# Record of Appeal for Public Space Permit for 701 10<sup>th</sup> St NE

## MEMORANDUM OF APPEAL

Re: **Application for public space permit at 701 10<sup>th</sup> St., NE**

**Re: Appeal of public space permit (701 10<sup>th</sup> St., NE)**

**Exhibit A**

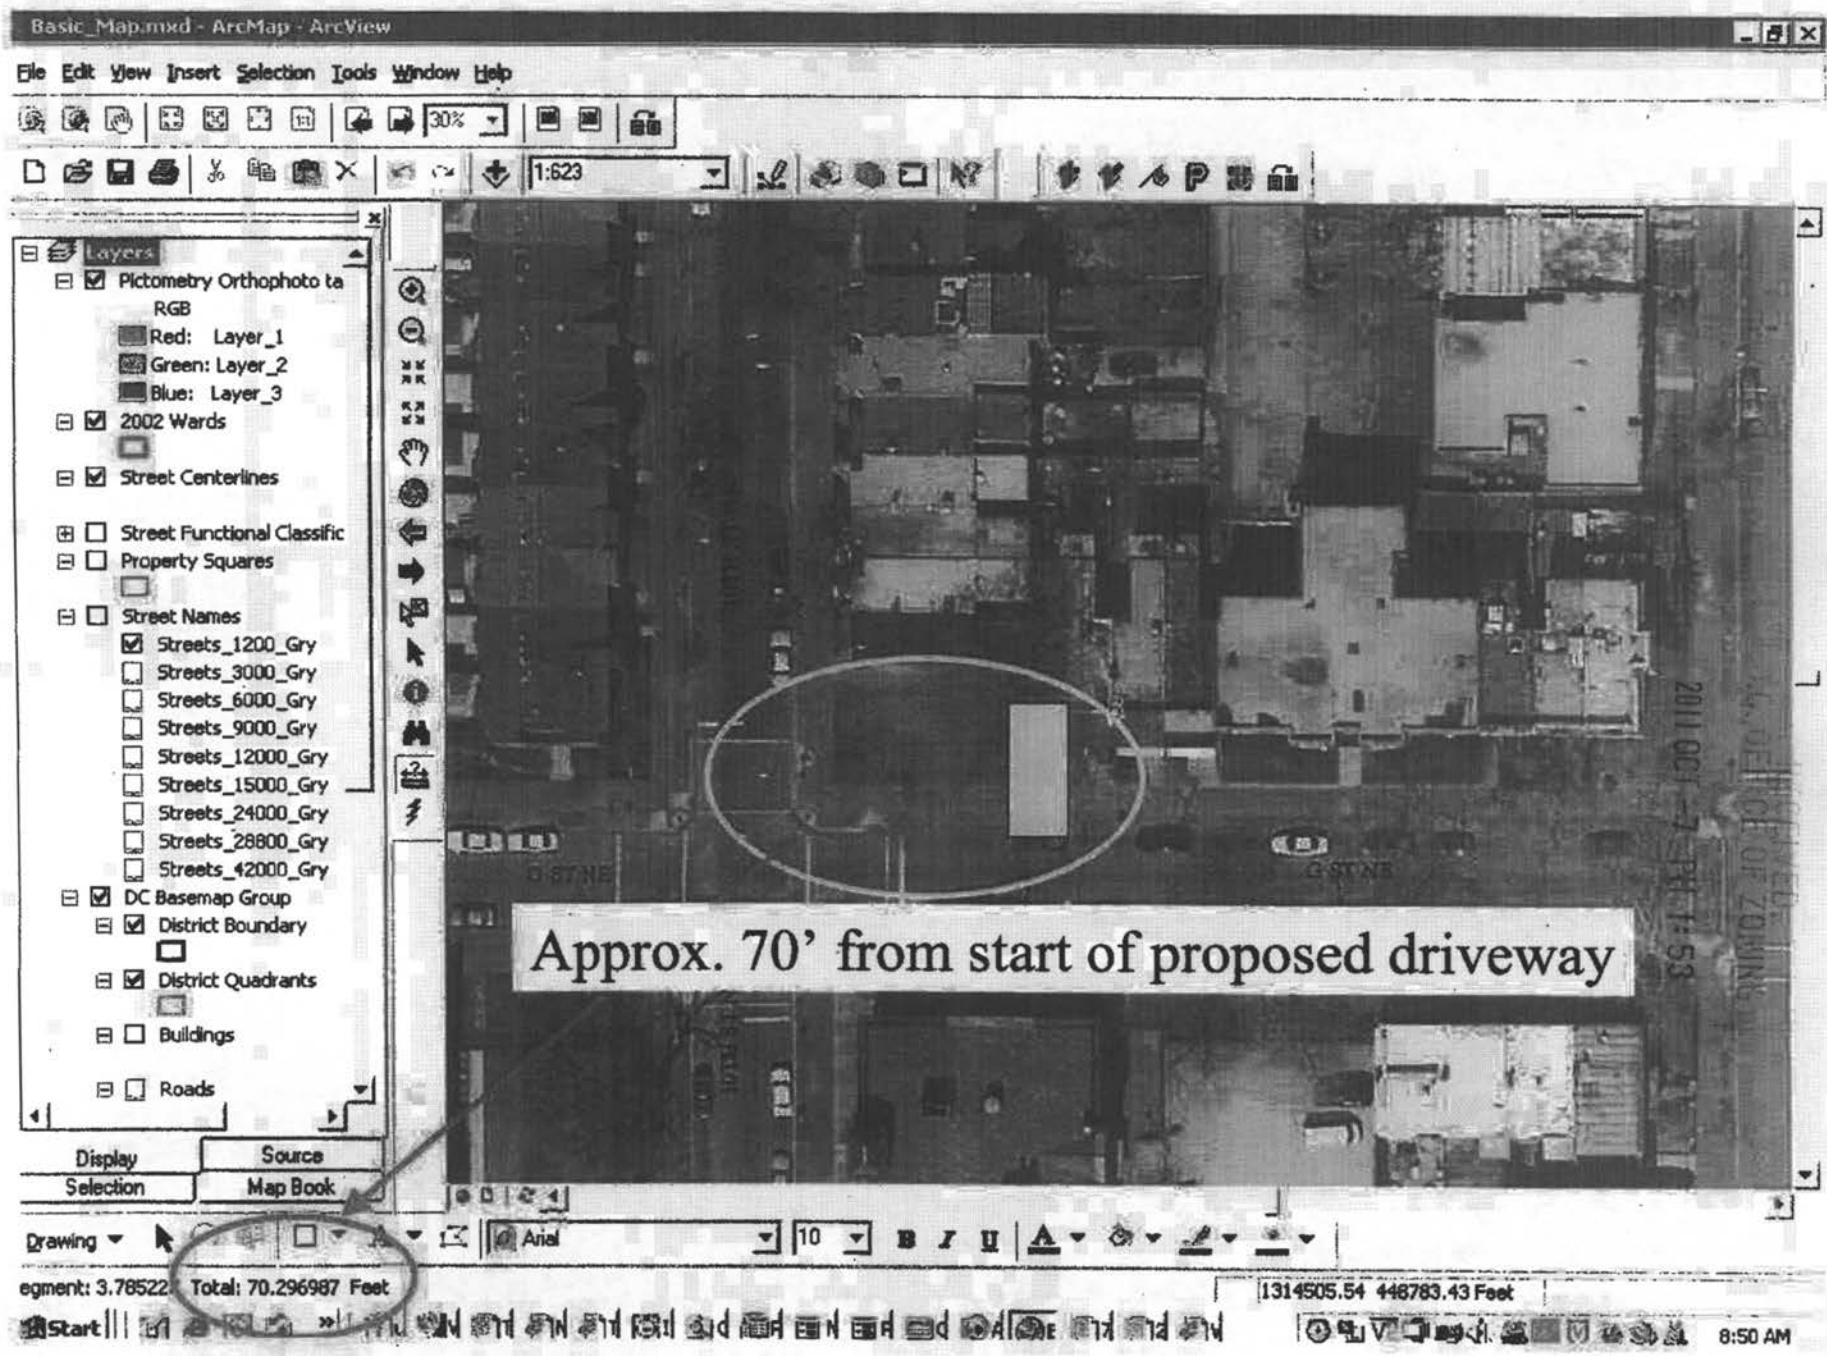
DDOT granted the Permit on the basis of incorrect measurements. All but one of the distance measurements in the administrative record were apparently taken on-site. Inexplicably, the only measurement for which DDOT relied on estimates from an electronic database instead of on-site measurements was the one for the distance from 10<sup>th</sup> Street, NE, to the edge of the proposed driveway. On the basis of this electronic estimate, DDOT concluded that the 10<sup>th</sup> Street, NE, intersection was "Approx. 70' from start of proposed driveway."<sup>1</sup>

<sup>1</sup> See Exhibit A, attached. DDOT's electronic approximation shows the driveway overlapping the neighboring property, which results in a greater distance between the intersection and proposed driveway.

DIAGRAM OF ACTUAL MEASUREMENTS  
AT 701 10TH ST., NE

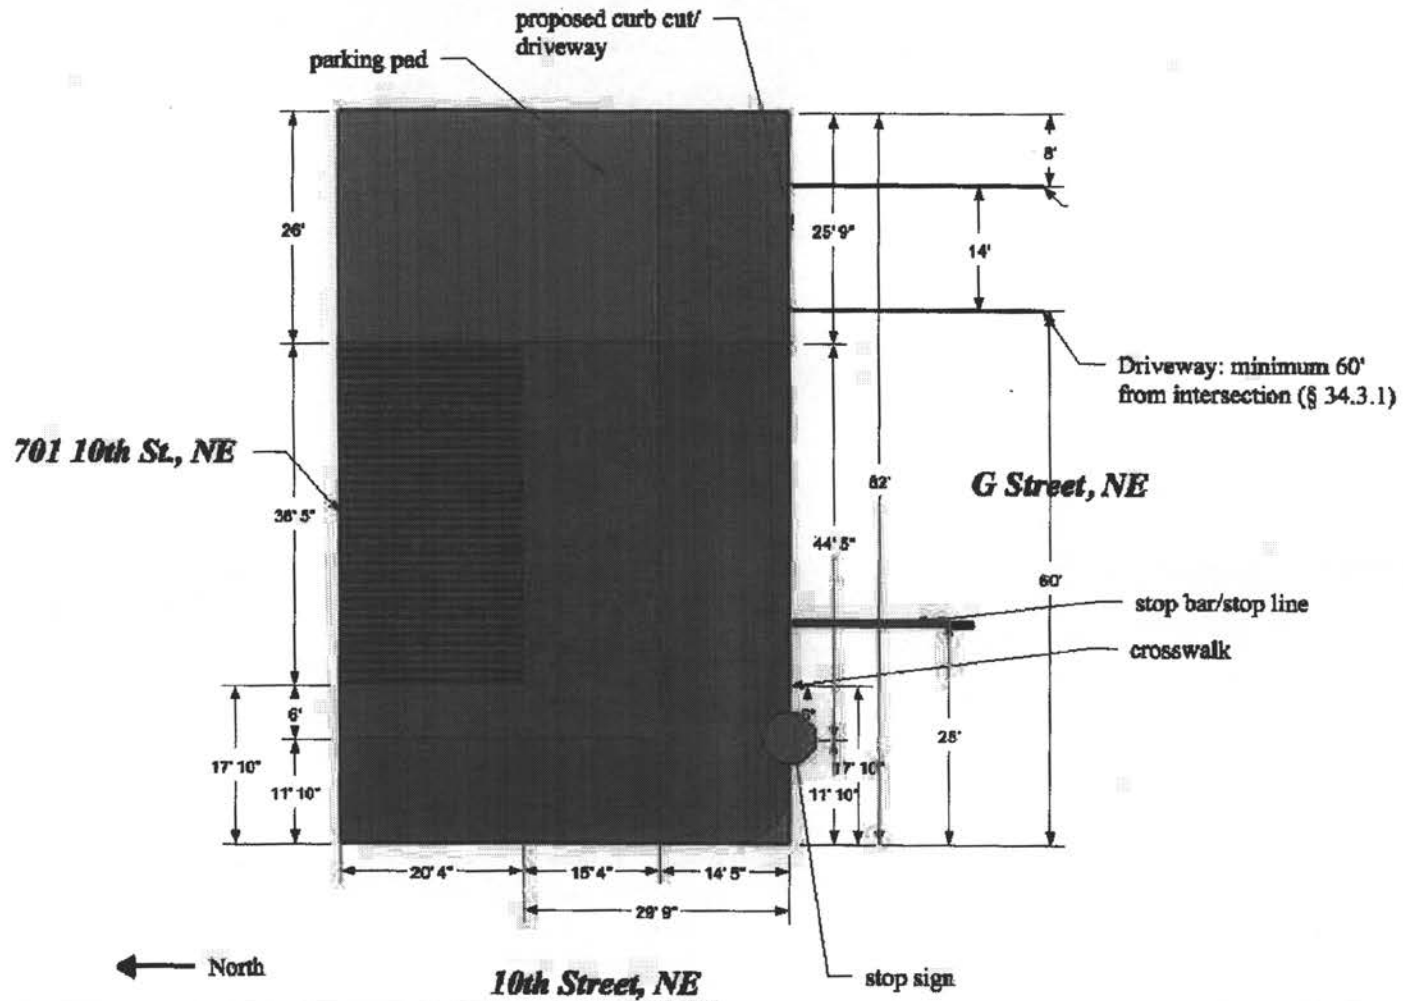
DDOT's electronic estimate is grossly incorrect. The Contractor's own Surveyor's Plat shows that a 24-foot wide driveway will be somewhere between 30 ft. 11 in. and 47 ft. 8 in. from the intersection.<sup>2</sup> The actual measured physical distance from the intersection to the edge of the permitted driveway is, at most, 57 feet.<sup>3</sup> In either case, the distance from the intersection to the

<sup>3</sup> See Exhibit B (Diagram of Actual Measurements at 701 10<sup>th</sup> St., NE, enclosed).

edge of the property line is only 82 ft. Therefore, any driveway that is 25 feet wide necessarily will fall within 60 feet of the intersection.<sup>10</sup> In short, it is impossible for *any* two-car driveway at the Property to comply with both TSA's requirements and DDOT's Design and Engineering Manual.
